[Docket No. FAA-2024-0769; Project Identifier AD-2023-00556-T; Amendment 39-22815; AD 2024-16-09]

Airworthiness Directives; The Boeing Company Airplanes

ACTION: Final rule.

SUMMARY: The FAA is adopting a new airworthiness directive (AD) for certain The Boeing Company Model 777-200, -200LR, -300, -300ER, and 777F series airplanes. This AD was prompted by a report indicating multiple findings of cracks in the fuselage skin common to the underwing longeron (UWL). This AD requires external or internal (depending on configuration) inspections for any cracking of the left and right side fuselage skin common to the UWL, and applicable on-condition actions. The FAA is issuing this AD to address the unsafe condition on these products.

Figure 1 to Paragraph (h)(3)—Cap Sealing Dimensions (all Dimensions are in Inches)

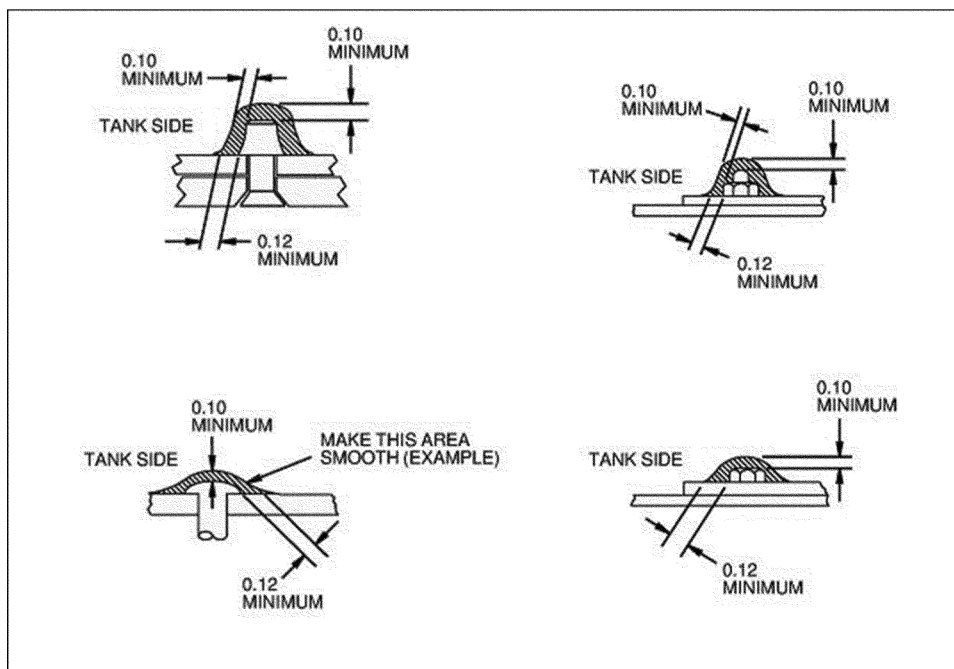
Boeing requested that paragraph (h)(3) of the proposed AD be clarified to specify that only the fuel tank side of fastener locations that penetrate the fuel tank boundary require cap seal dimensions to meet the dimensions given in Figure 1 to paragraph (h)(3) of the proposed AD. Boeing stated that the service information referenced in Boeing Alert Requirements Bulletin 777–53A0100 RB, dated March 16, 2023, contain instructions for applying cap seals to fasteners that penetrate a fuel tank boundary and fasteners that do not penetrate a fuel tank boundary. Boeing added that for fasteners that do not penetrate a fuel tank boundary, fastener sealing is used as a pressure seal to help mitigate corrosion and have sealing specifications that include minimum thickness requirements less than the amount shown in paragraph (h)(3) of the proposed AD that are acceptable for their intended function outside of the fuel tank. Boeing stated that for fasteners that penetrate the fuel tank, the cap seals on the interior side of the fuel tank act as a primary fuel seal, providing fault tolerance against electromagnetic effects (electrical fault currents and lightning currents), and are also cap sealed on the exterior side for corrosion prevention.

Boeing concluded that only the cap seals on the interior side of the fuel tank require the dimensions specified in Figure 1 of paragraph (h)(3) of the proposed AD to perform their intended function, which is consistent with the labels shown in Figure 1 of paragraph (h)(3) of the proposed AD. Boeing recommended replacing the text “applying a cap seal (sealant) to a fastener, fastener head, and fastener threads and collars, for this AD, during application of any cap seal to a fastener, fastener head, or fastener threads and collars” with the text “applying a cap seal (sealant) to a fastener location that penetrates the fuel tank boundary, for

Boeing requested that the FAA add a note to paragraph (h)(3) of the proposed AD to refer to Boeing Model 777 Aircraft Maintenance Manual (AMM) section 28–11–00 as an acceptable cap sealing procedure to accomplish the actions required in that paragraph. Boeing stated it has received numerous queries from operators on Figure 1 to paragraph (h)(4) of AD 2023–17–14, which is identical to Figure 1 to paragraph (h)(3)

of the proposed AD. Operators have asked whether Boeing Model 777 AMM section 28–11–00 would be an acceptable procedure for accomplishing the requirements of paragraph (h)(4) of AD 2023–17–14. Boeing stated it believes that AMM 28–11–00 is an acceptable procedure for performing cap sealing inside the fuel tank because the AMM is the source material for the contents in Figure 1 to paragraph (h)(3) of the proposed AD and contains the same minimum seal thickness dimensions as shown in Figure 1.

The FAA agrees to clarify paragraph (h)(3) of this AD for the reasons provided by the commenter. Locations that do not penetrate the fuel tank boundary do not require the same sealant application procedures. The FAA has added the text “inside the fuel tank” to paragraph (h)(3) of this AD. However, the FAA did not replace the text “to a fastener, fastener head, and fastener threads and collars” with the text “to a fastener location that penetrates the fuel tank boundary,” as recommended by the commenter, because the text “to a fastener, fastener head, and fastener threads and collars inside the fuel tank” better aligns with the language within the service information.

The FAA agrees. Boeing 777 AMM 28–11–00 meets the sealant requirements of Figure 1 to paragraph (h)(3) of this AD. As such, it would be an acceptable procedure to follow when sealing inside the fuel tank in accordance with paragraph (h)(3) of this AD. The FAA has added a note to paragraph (h)(3) of this AD accordingly.
